October 3, 1980

Re: Nine Mile Point Unit 2
Docket No. 50-410

Your letter of July 9, 1980 requested additional information regarding geology at Nine Mile Point Unit 2. Enclosed are Niagara Mohawk's responses to questions Q361.26 through Q361.35 contained in the enclosure to your letter.

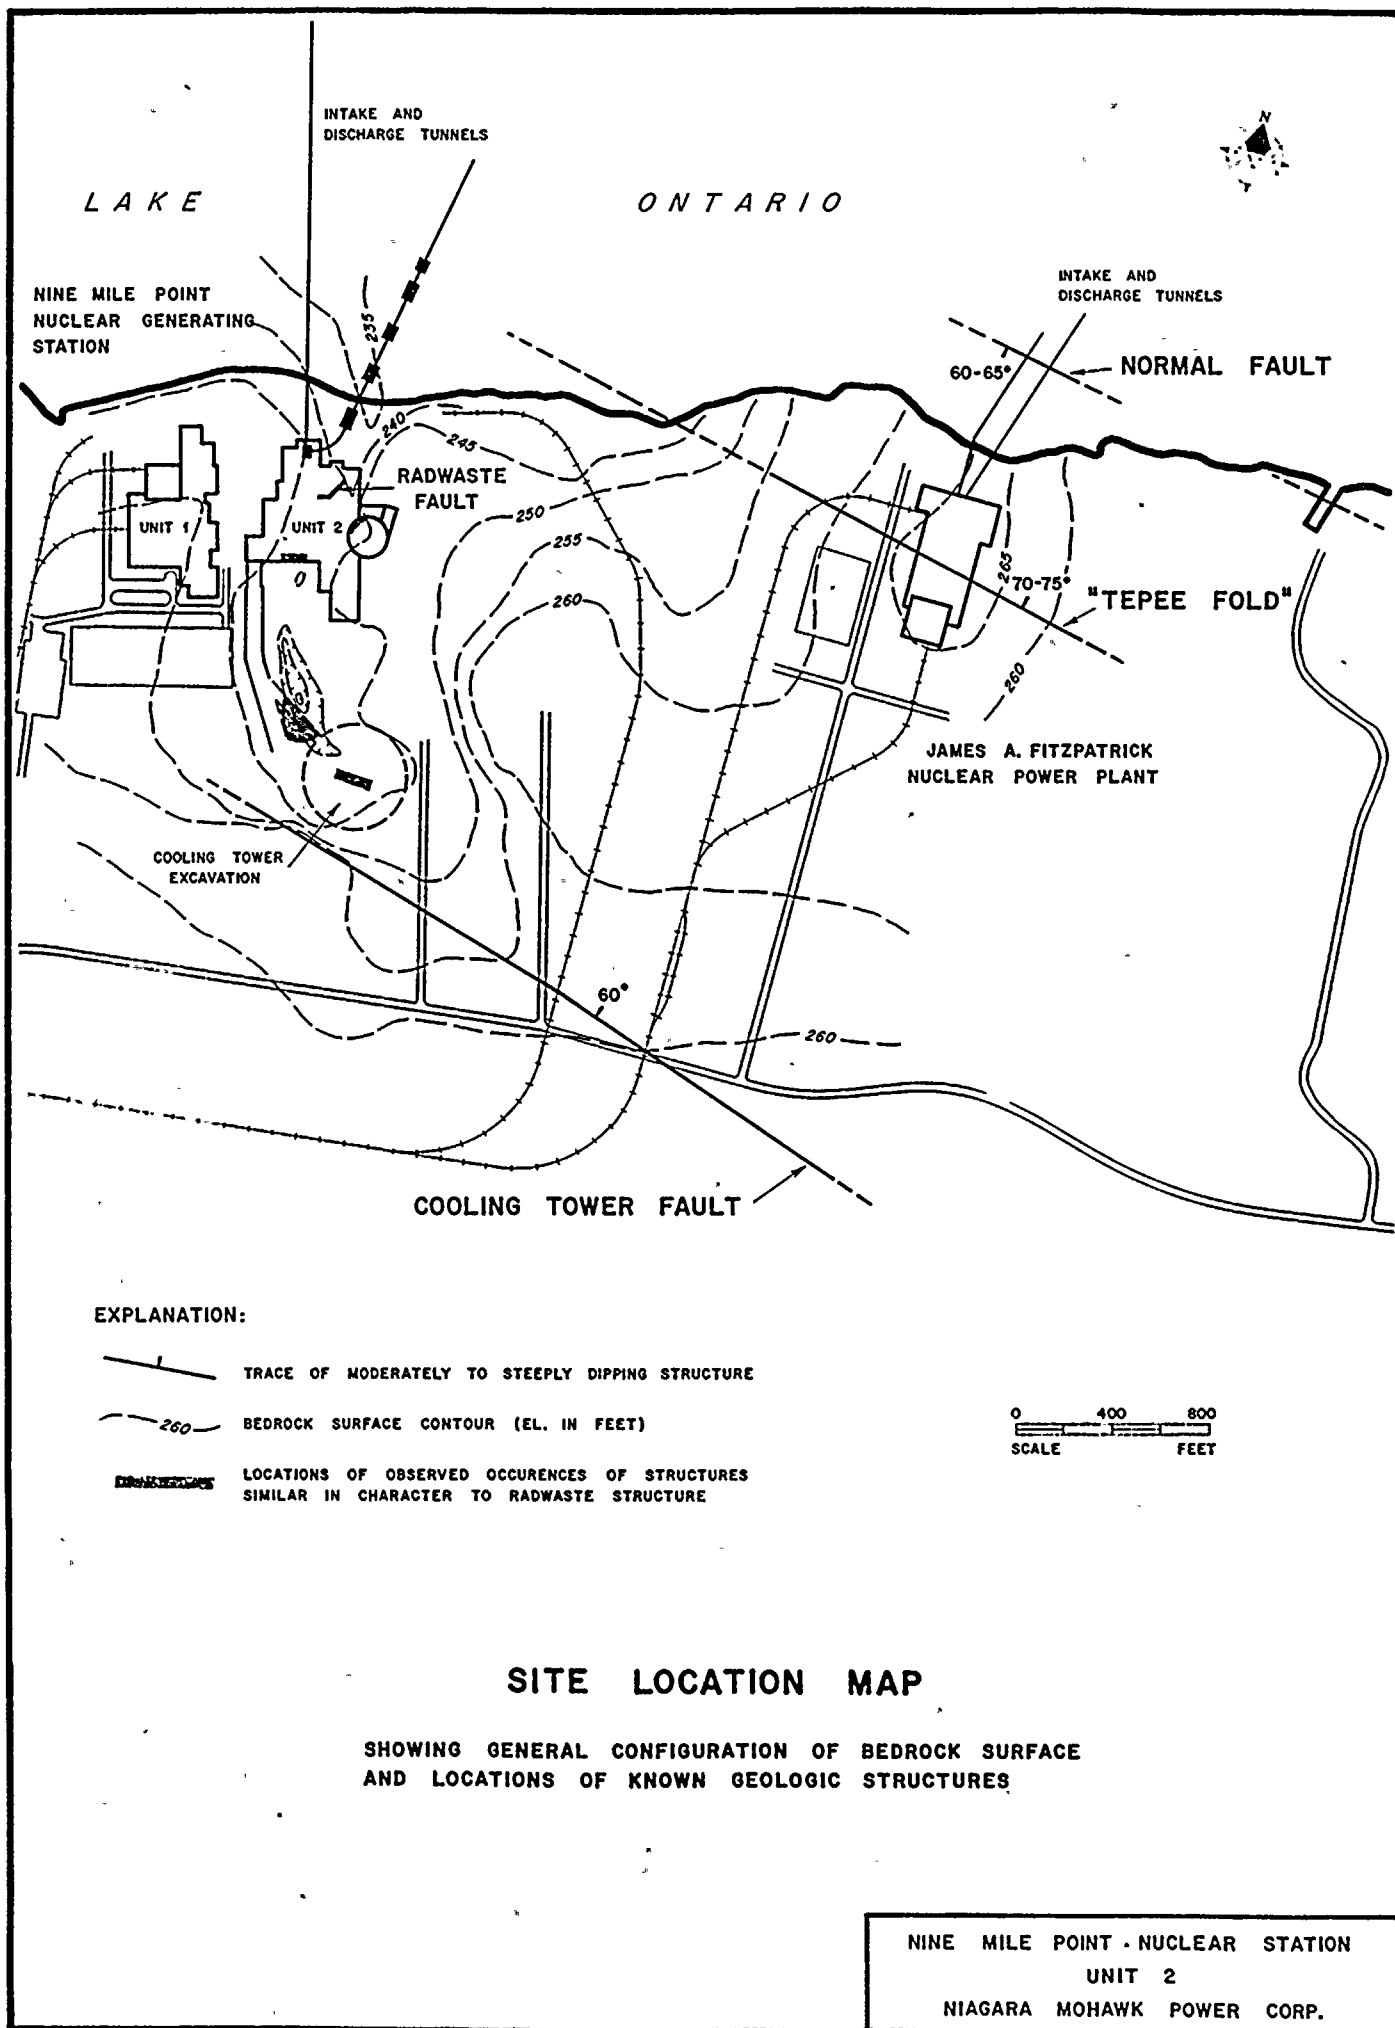
Q361.28 Indicate the relationship among the thrust faults, the cooling tower fault, and the drainage ditch fault. Specifically, indicate whether they connect as an integrated system and whether the thrust faults cut the other faults.

- 1) the lateral restraining force provided by the bedrock which has been removed by erosion during the formation of the north-south trending erosional valley located between Nine Mile Point Units I and II (Figure 361.28-1);
- 2) the shear resistance of the boundaries of the block consisting of following elements (Figure 361.28-2):
 - a) shear resistance along boundary 1

Considering the foregoing, the following scenerio of development of the "thrust fault structures can be outlined:

- (i) Downwarping of the crust in relation to glacial advance created conditions favorable for buckling of the hanging wall blocks of northward dipping high-angle faults. This resulted in a reduction of σ_{n_2} and hence reduction of dS_1 and dS_2 ;
- (ii) erosional formation of the valley reduced lateral restraining force, and;
- (iii) removal of the load imposed by the continental ice sheet reduced σ_{n_1} and, thus reduced dS_3 . Further reduction of σ_{n_1} , and dS_3 may have occurred during the drainage of Lake Iroquois (development of high fluid pressure in the bedrock).

DIAGRAM SHOWING RELATIONSHIP BETWEEN STRATIGRAPHIC
DISPLACEMENT AND DEPTH IN BORINGS T-3-1 THROUGH T-3-10

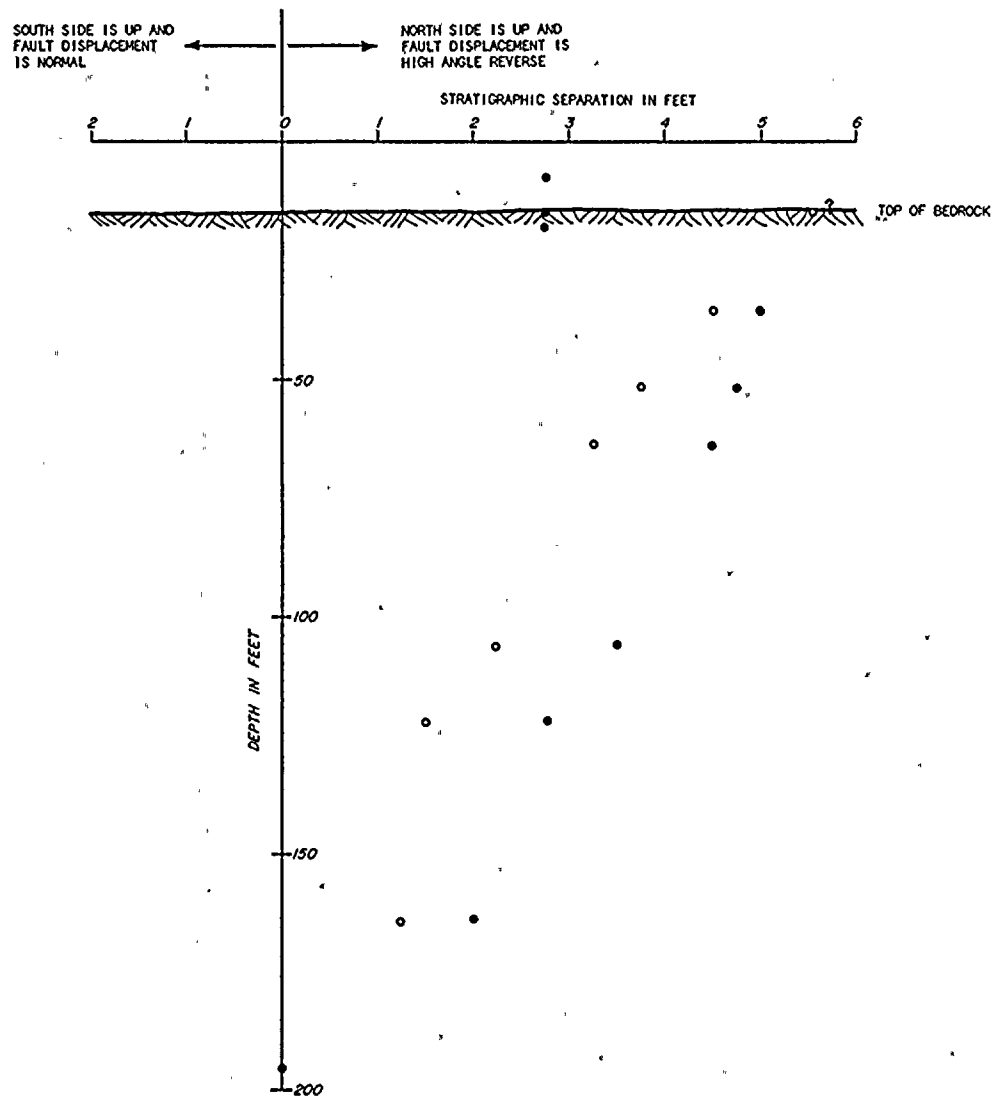
Q361.30 Furnish additional discussion and documentation to support your conclusion that post-glacial reverse movement did not occur below 200 feet on the cooling tower fault. Our concern in this matter is that if this fault had previous normal movement as you suggest, and if the displacement on this fault is presently zero at the 200 foot depth, then it appears that reverse movement must have occurred below the 200 foot level to bring the net displacement to zero.

- (i) the stratigraphic separation resulting from the reverse-slip movements varies in a linear manner with depth. Figures 361.30-1 and 361.30-2 present

the relationship of stratigraphic separation and depth. It can be seen that downward the separation becomes progressively smaller. At a depth of approximately 200 feet there is no relative displacement of the strata;
